# **CITY OF RIALTO**

## **ADDENDUM NO. 1**

**RE:**            Fergusson Park, City Project No. 103003-00  
Rialto, CA

**CITY OF RIALTO**  
 FERGUSSON PARK  
 IRRIGATION PLAN  
 PPD No. \_\_\_\_\_  
 FOR: CITY OF RIALTO  
**IP-2**  
 OF 57 SHEETS  
 PLAN No. \_\_\_\_\_

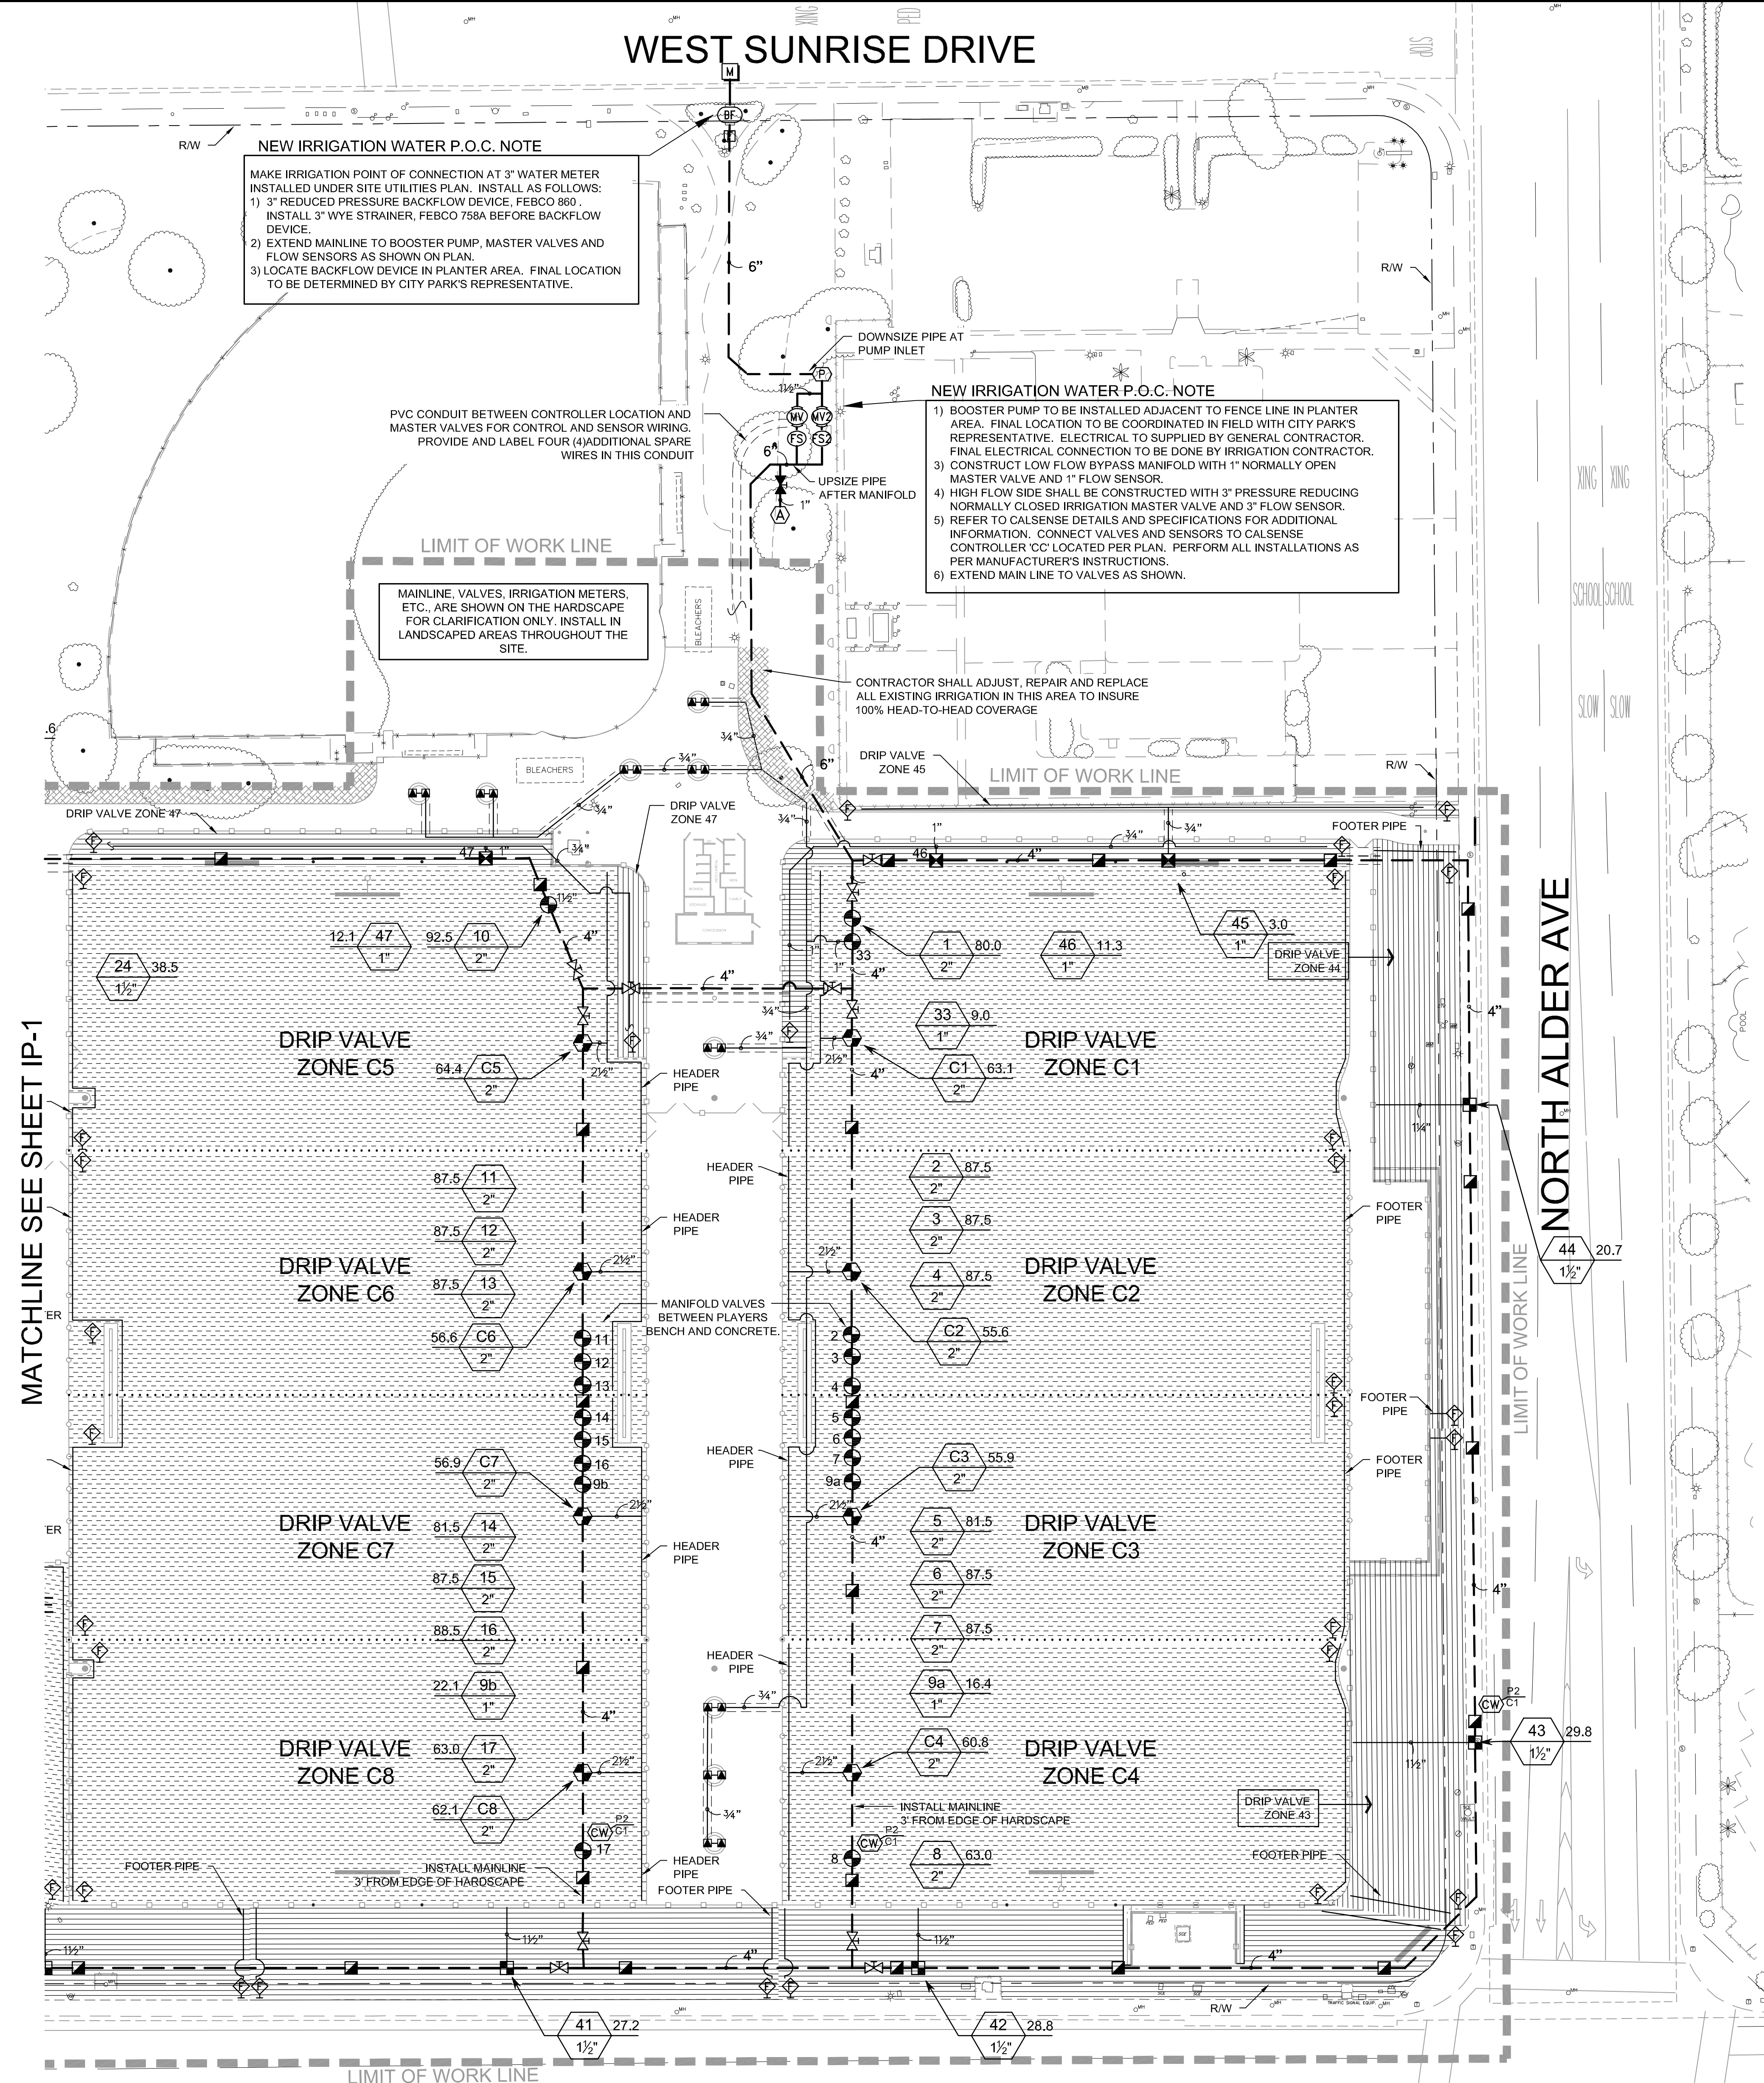
6. Provide complete and operable public address system per attached specifications and bid set electrical plans.
7. Provide cost for subterranean irrigation system in turf areas per attached plan. Replace existing page P 8 of the specifications with the attached page.
